# SERVICE BULLETIN

**Service Bulletin No.:** DAC1-24-03 Rev.1

**Title:** G-35M Battery, Optional Installation

**2. Effectivity:** DA20-C1 Aircraft

Figure 1

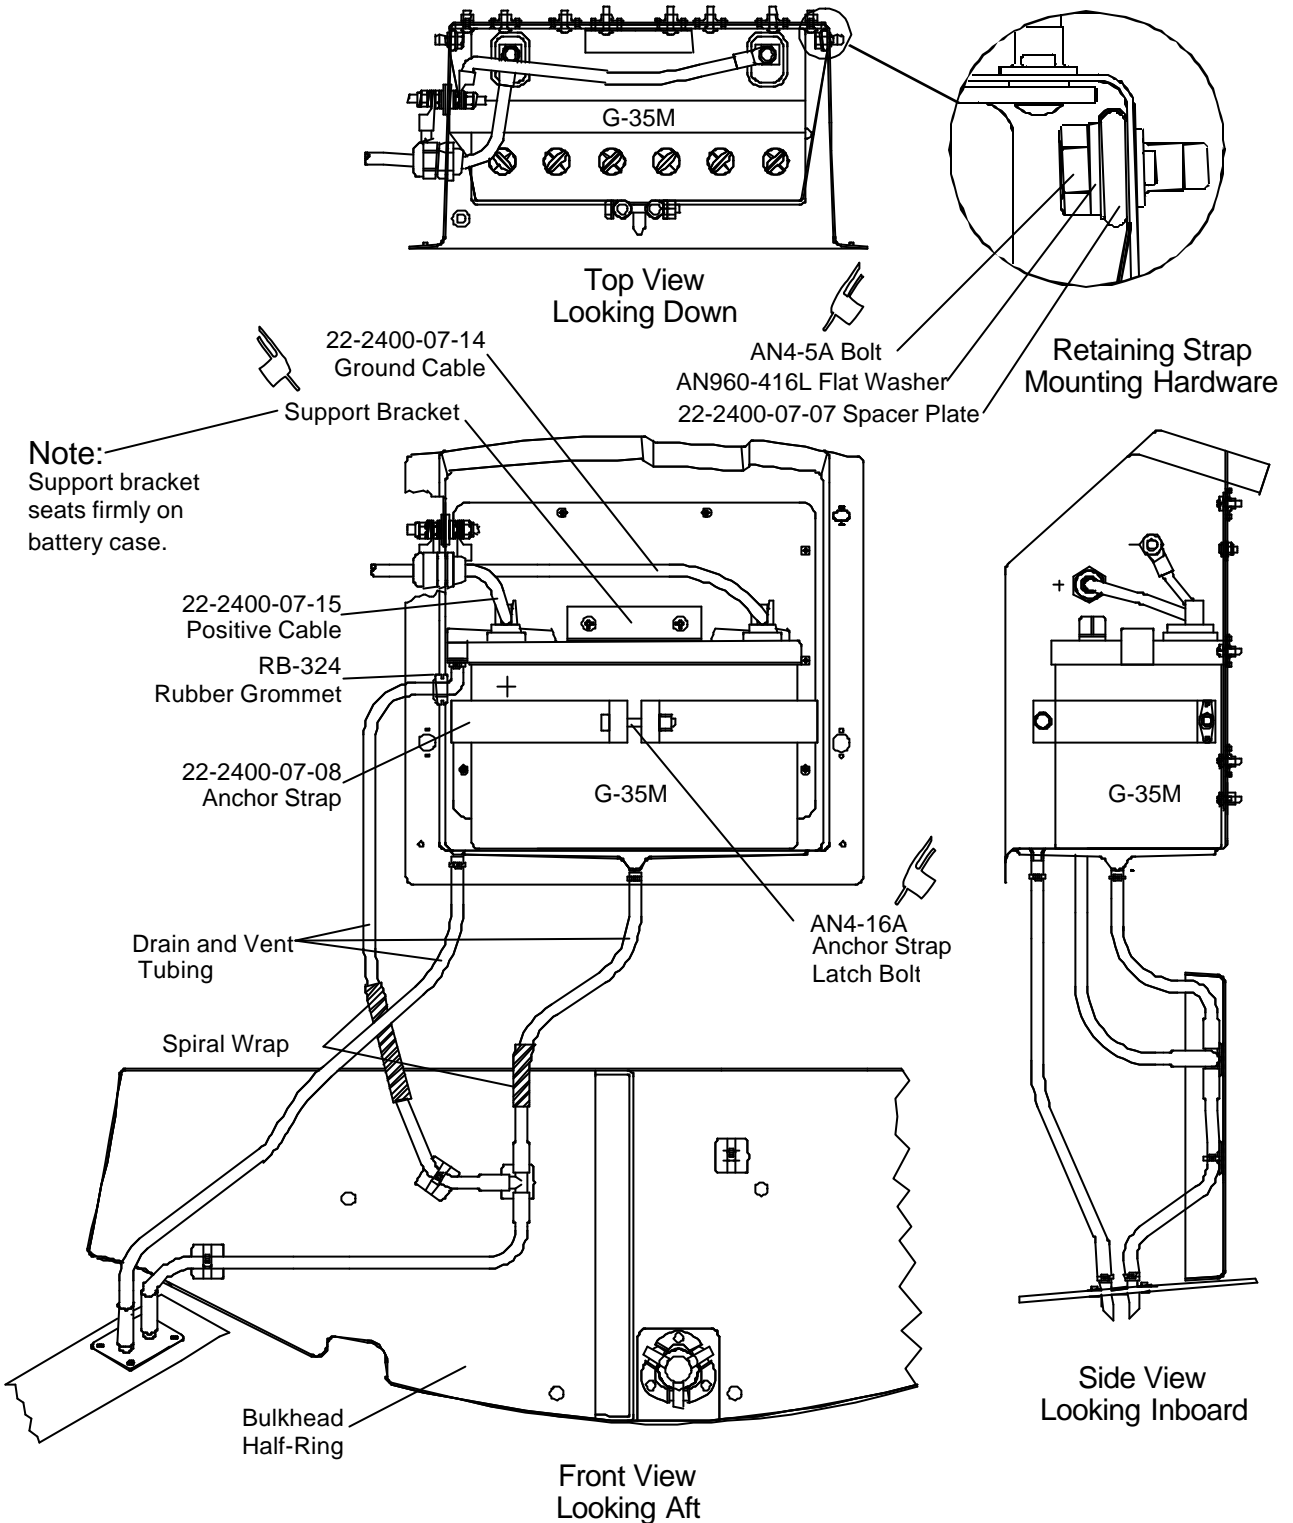
- 10.4** Remove the rubber plug from right side of battery housing and install the new rubber grommet as in Figure 1.
- 10.5** Reroute the vent and drain tubing as in Figure 1.

- 10.6** Install the new anchor strap mounting hardware as in Figure 1.
- 10.7** The new positive cable terminal has a larger diameter (5/16"Ø) ring terminal at the battery end. Do one of the following procedures:

- 10.8** Install the new rubber plug in the left side hole in the battery housing.
- 10.9** Install the new battery (reference DA201-C1, chpt. 24-31, sec. 3B). Discard old anchor strap latch bolt and install new bolt P/N AN4-16A as in Figure 1.

- 10.10** Install the support bracket. Elongation of the housing holes may be necessary for proper fit on the battery (see Note in Figure 1).
- 10.11** Update the Airplane Flight Manual weight and balance record.
